DAIMLER

Q3 Scapula – Proposed Modification

2016-03-04

Q3 versus Q6 scapula

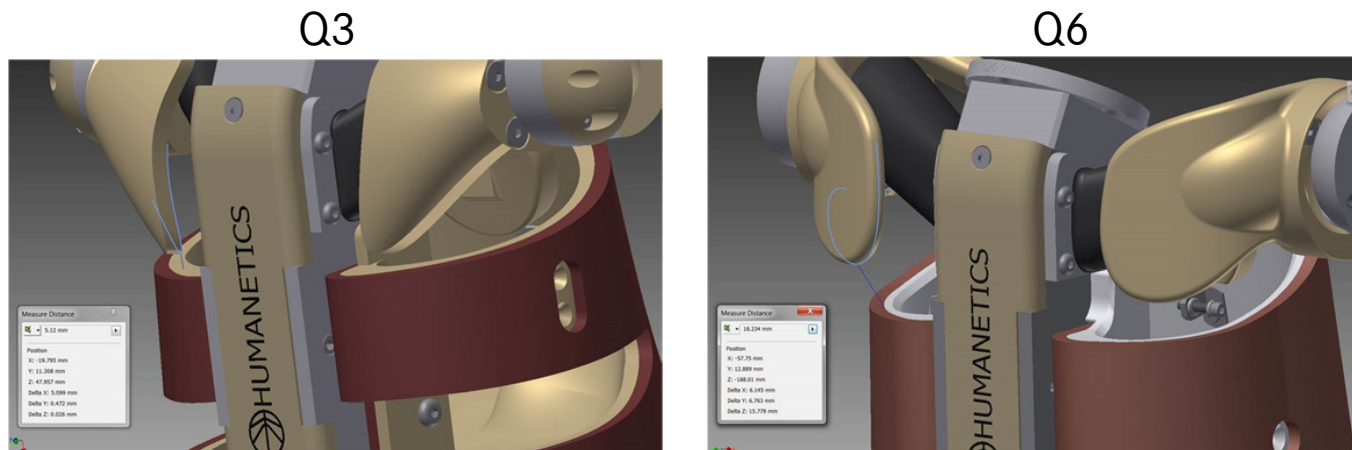
- As recommended by Daimler Humanetics compared the Q3 design against the Q6 design
- The Q6 has 13 mm more clearance between scapula and rib cage.
- The Q3 seems to have a more natural shape of the scapula while in the Q6 it is reduced in size.
- No documentation was found on the reasoning for this but when checking with the design engineers this was related to risk for contact in the Q6

Comparison for Affect on Seating

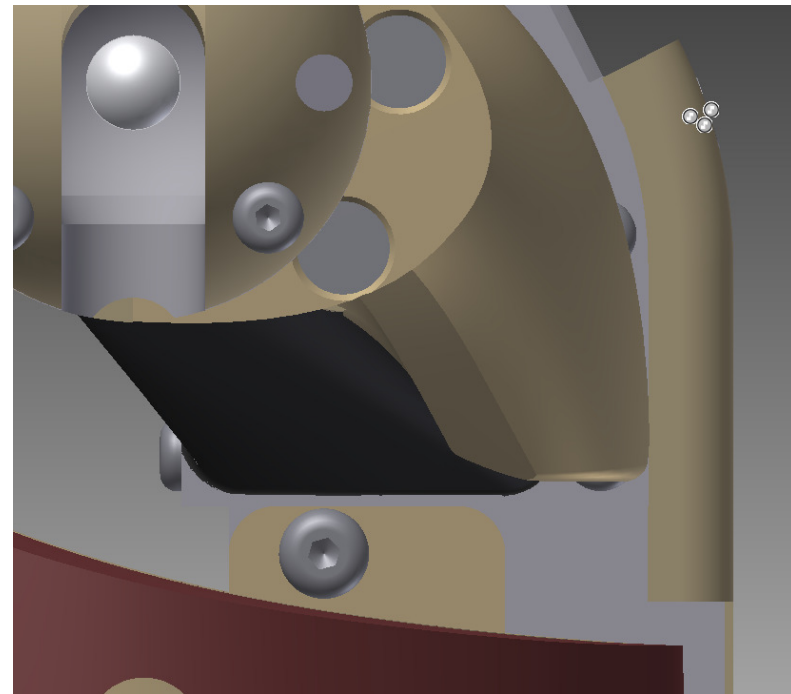
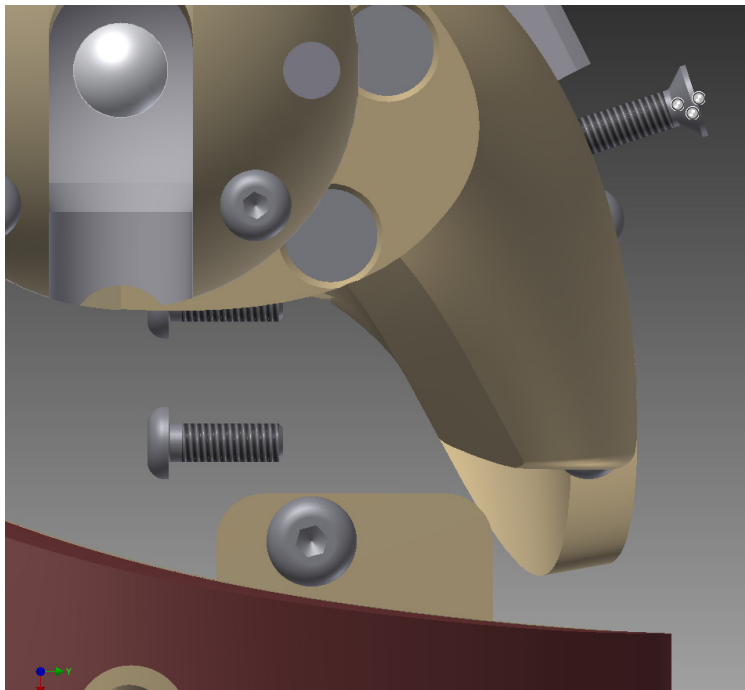
- Below on the left shows a CAD picture looking directly from the side with the current scapular behind. Spine, shoulder rubbers and cable cover hidden. On the right these parts are shown.

- It is recommended to take off 11.5 mm from the lower end of the Q3 scapula
- This will maintain the same seating position of the dummy while generating a clearance with the rib cage of 16.5 mm which is more in line with Q6
- Minor mass change of about 1 gram on each side
- Changes to be included in Q3 dummy drawing package to be updated by Mid 2016 related to items like APTS sensor and hip-liner
